# Access Compliance Report

## Public Rights-of-Way

### (Curb Ramps)

Intersection ID: 2897	Main Street: BELL'S_MILL_DR	Cross Street: HARBURN_FOREST_DR	Location: SE
ADA ID: EC1D5BE06A0F	Ramp Type: PerpDiag	Initial Pass/Fail: Pass	Overall Compliance: No
Severity Score: 22.75			
Codes/Mitigation Info/Possible Solution		Field Measurements/Component Compliance

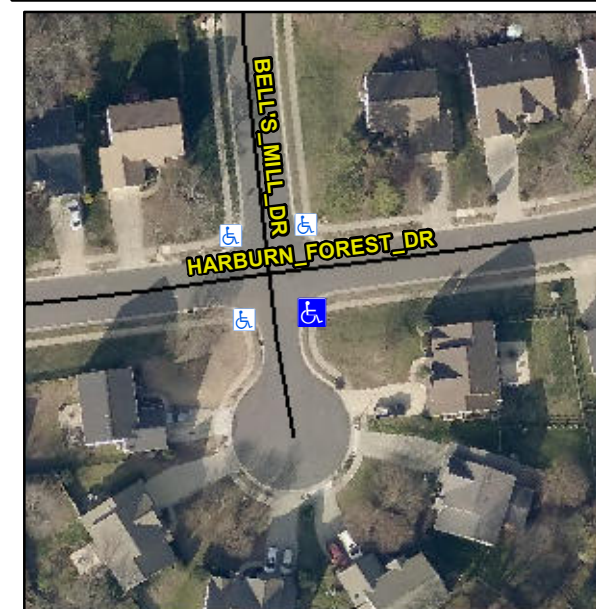
**Not Found, R304.5.3, R304.2.2-Perp, R304.3.2-Para, R305, R302.7.2, R304.5.4**

Compliance	Description	Data	Compliance	Description	Data
N/A	Ramp Length (in)	36.0	Yes	Ramp Slope (%)	6.7
Yes	Ramp Width (in)	72.0	No	Ramp XSlope (%)	4.2
N/A	Flare Type LT	Sloped	N/A	Flare Type RT	N/A
N/A	Flare Slope LT (%)	3.6	Yes	Flare Slope RT (%)	6.9
N/A	Flare Traversable LT?	Yes	N/A	Flare Traversable RT?	Yes
Yes	Landing Length (in)	48.0	No	DWS Provided?	No
Yes	Landing Width (in)	72.0	N/A	DWS Contrast?	No
No	Landing Slope (%)	2.8	N/A	DWS Length (in)	N/A
No	Landing X Slope (%)	4.1	N/A	DWS Full Width?	No
N/A	Landing Curb? (Y/N)	No	N/A	DWS Offset (in)	N/A
N/A	Shared Landing?	No			
Yes	Gutter Ponding?	No	No	Gutter Slope (%)	7.8
No	Gutter Lip Ht (in)	0.5	No	Gutter X Slope (%)	3.5
N/A	Painted X Walk1?	No	N/A	Painted X Walk2?	No
	X Walk 1 Direction	To N		X Walk 2 Direction	To W
N/A	X Walk 1 Width (in)	N/A	N/A	X Walk 2 Width (in)	N/A
	X Walk 1 Slope (%)	0.7		X Walk 2 Slope (%)	3.3
	X Walk 1 X Slope (%)	3.4		X Walk 2 X Slope (%)	0.1

**Remove & Replace Curb Ramp With Two New Directional Ramps or Equivalent. Remove & Replace Gutter.**
